REVIEWED 5/31/07

# FINAL DRAINAGE REPORT

## WOODLAND CREEK ESTATES SUBDIVISION

1802 K ROAD  
FRUITA, COLORADO

**WOODLAND CREEK ESTATES GRADING AND DRAINAGE PLAN**

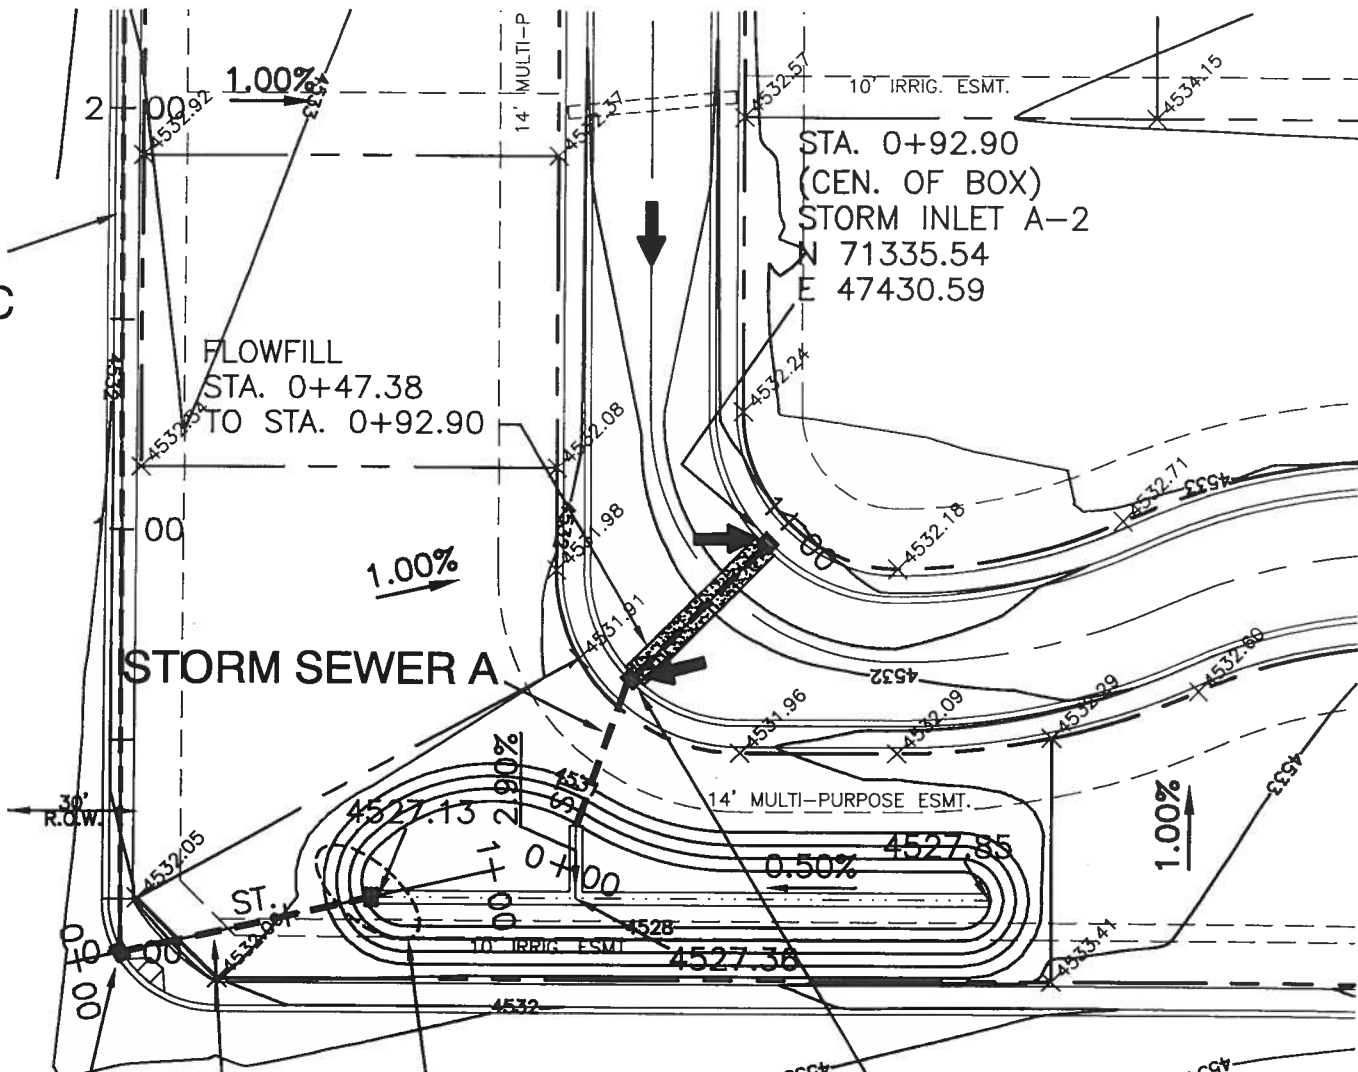
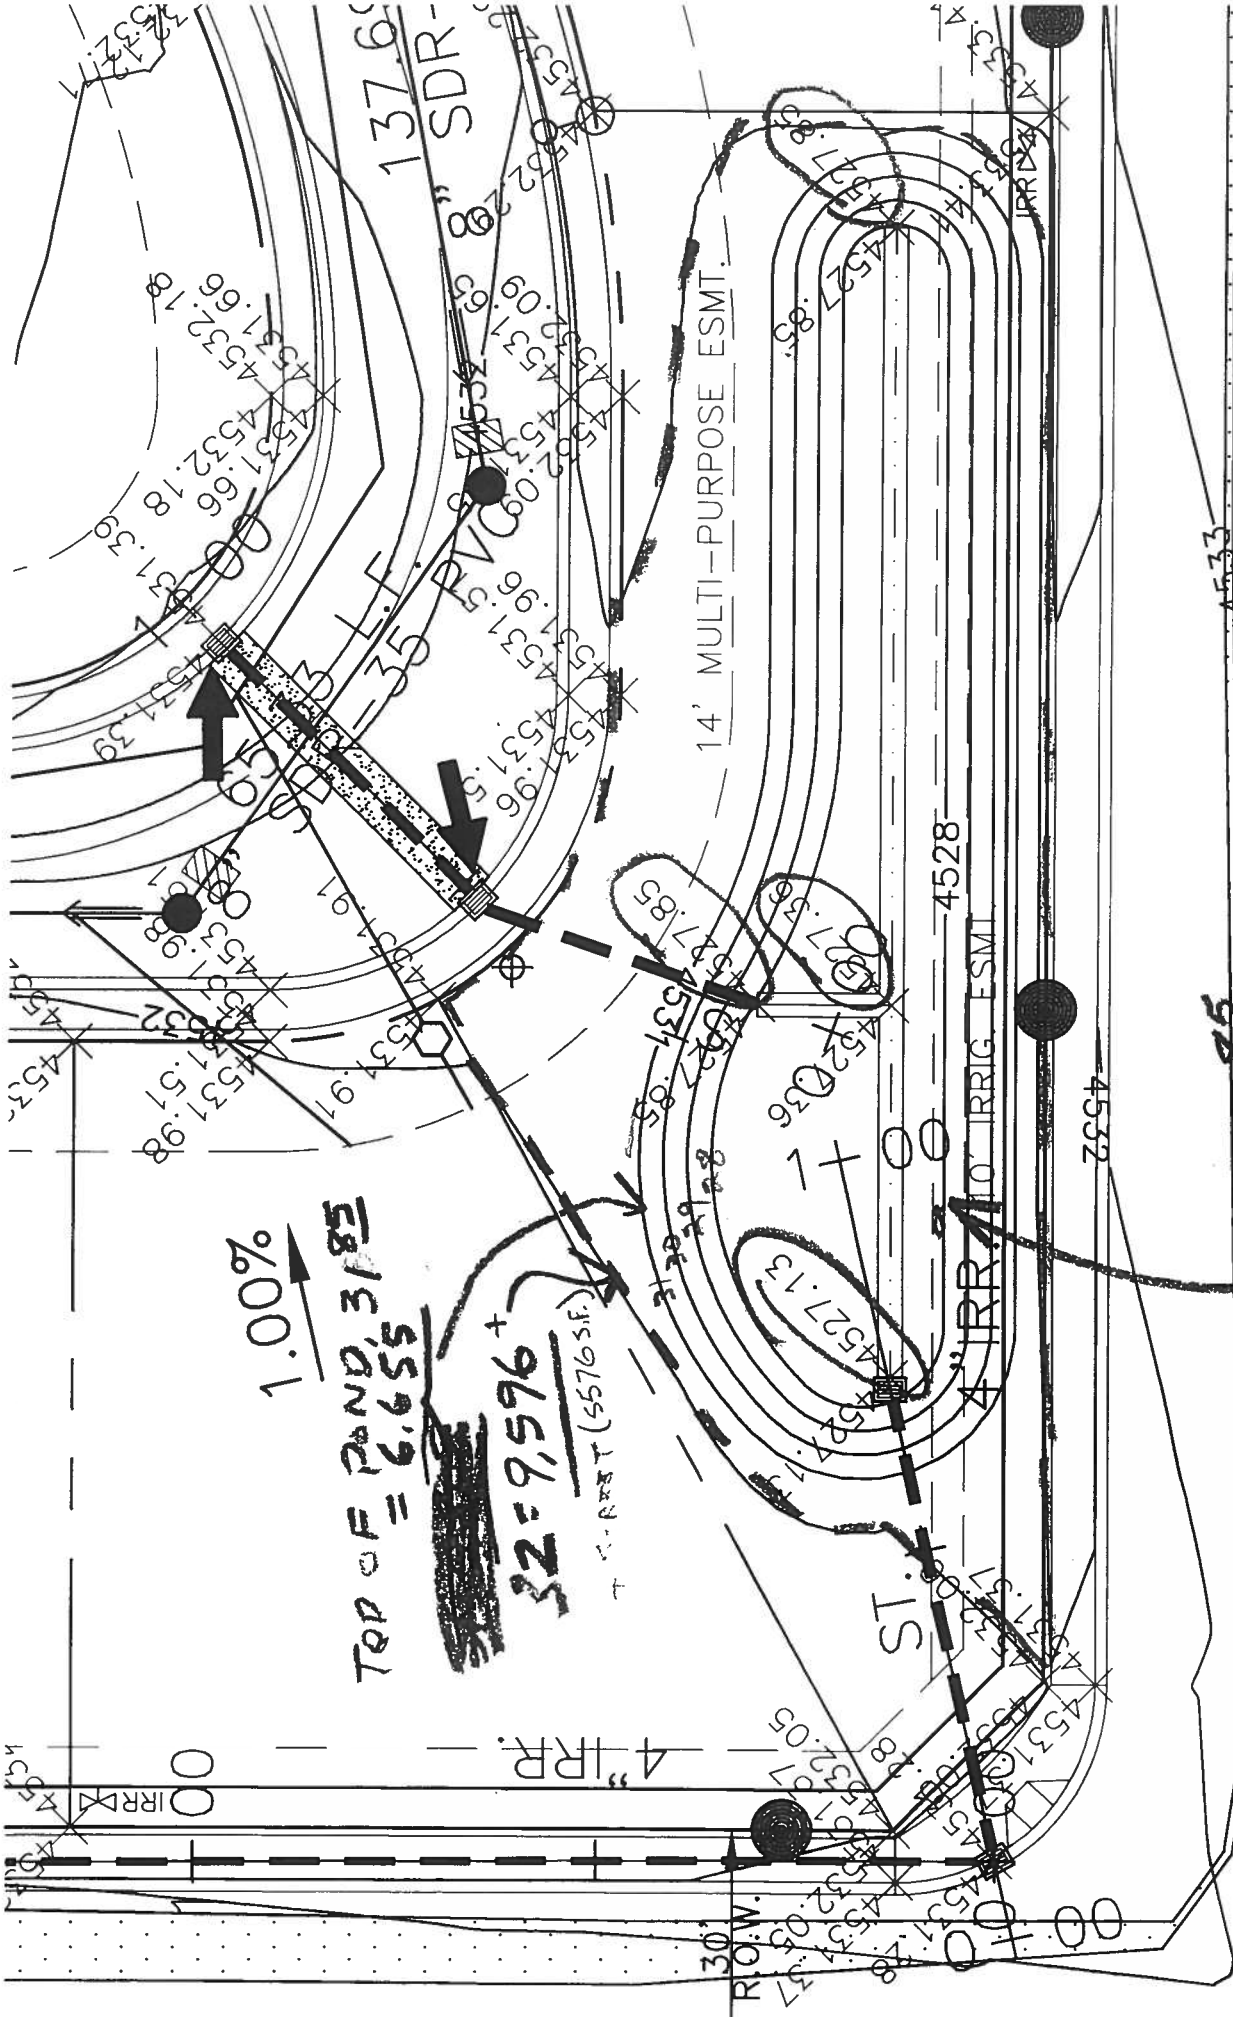
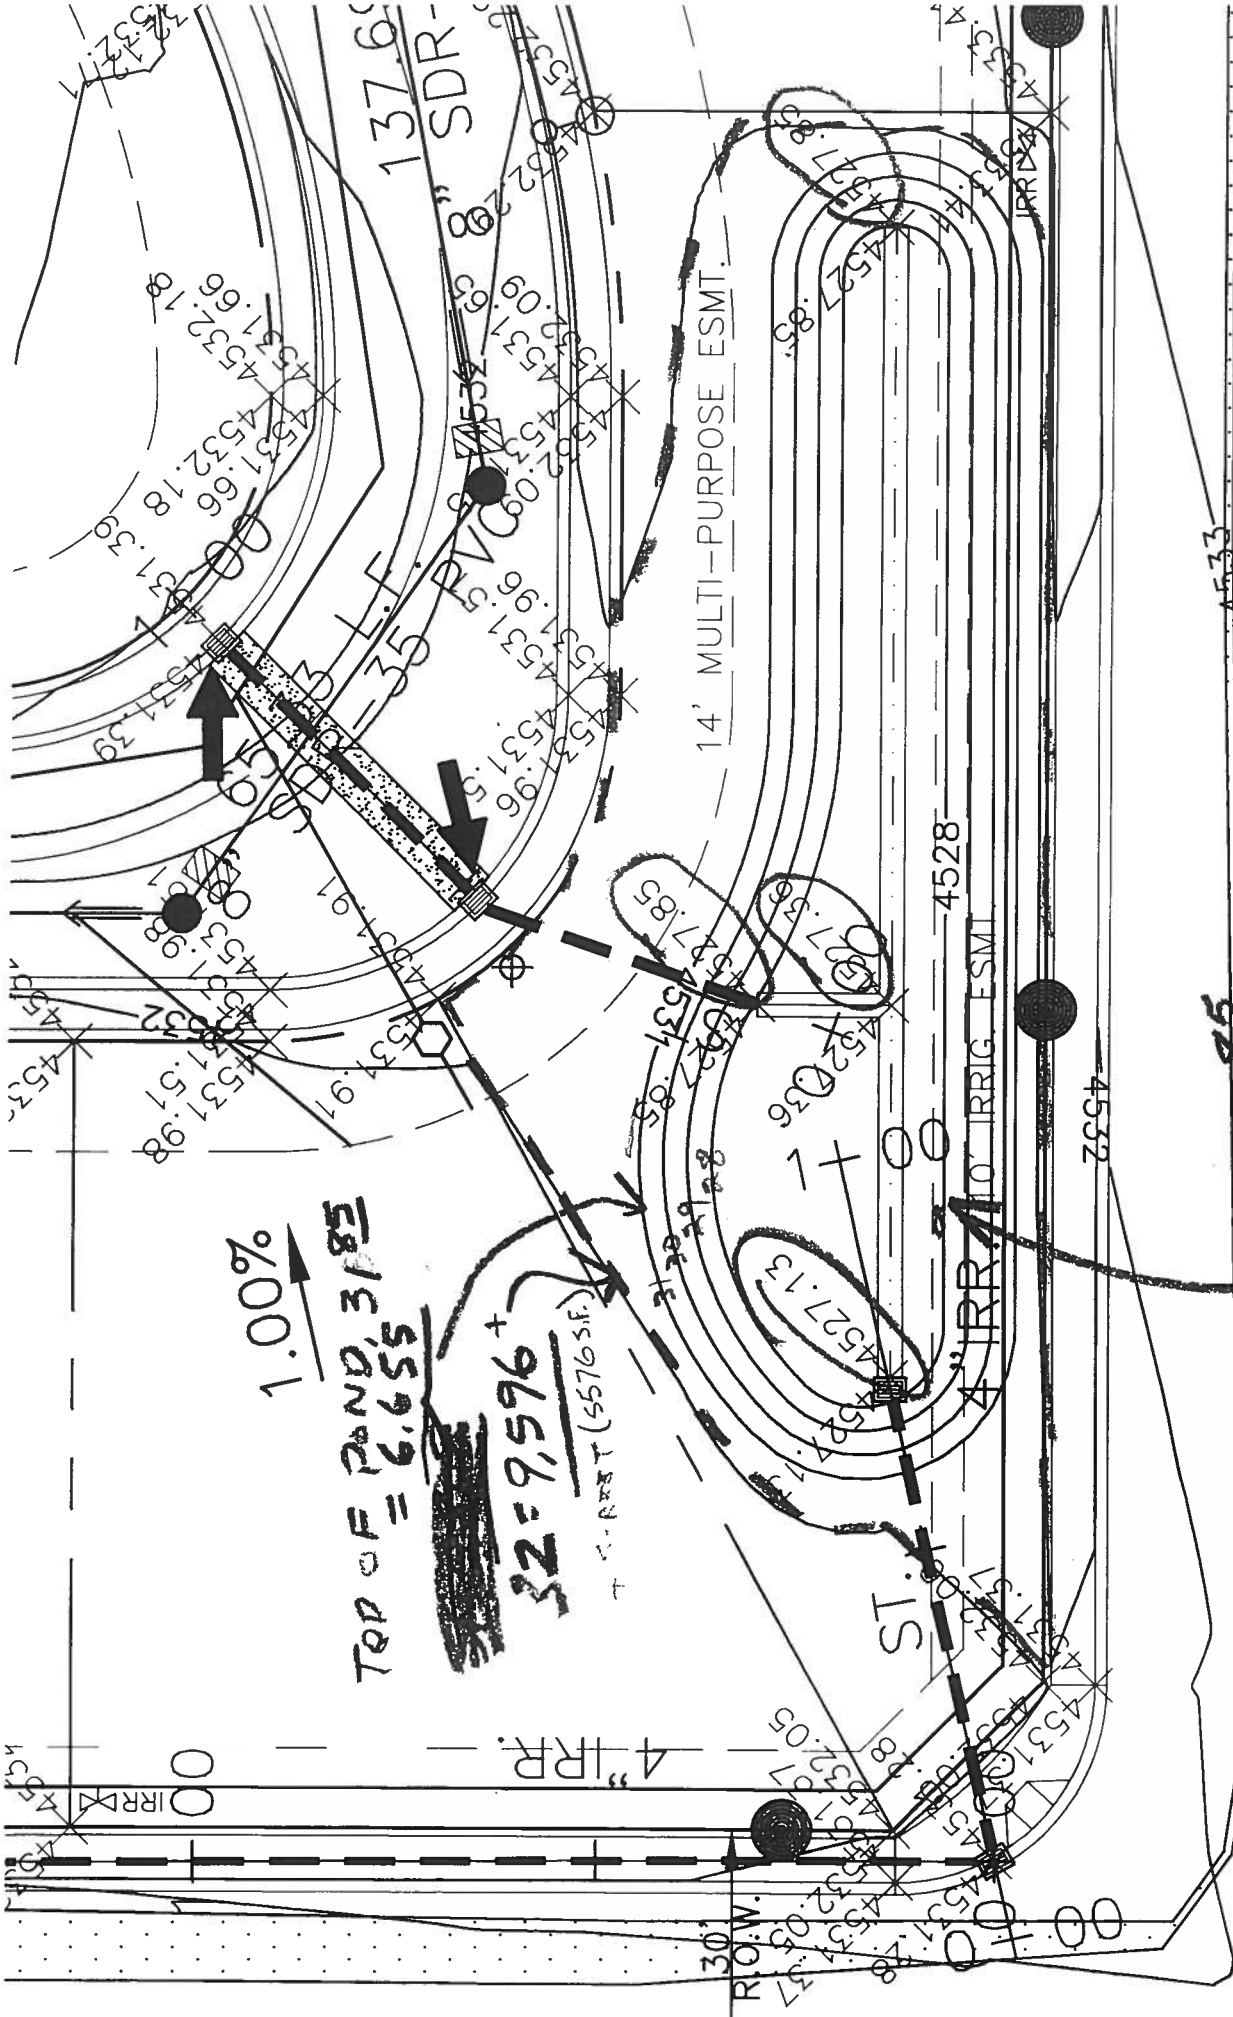
Storm Drain C = 12" ADS  
along Pine St. The 12"  
pipe capacity calculations  
of 2.67 cfs were found,  
but the design  $Q_{100}$  (needed  
volume) was never found.  
This needs to be clarified.
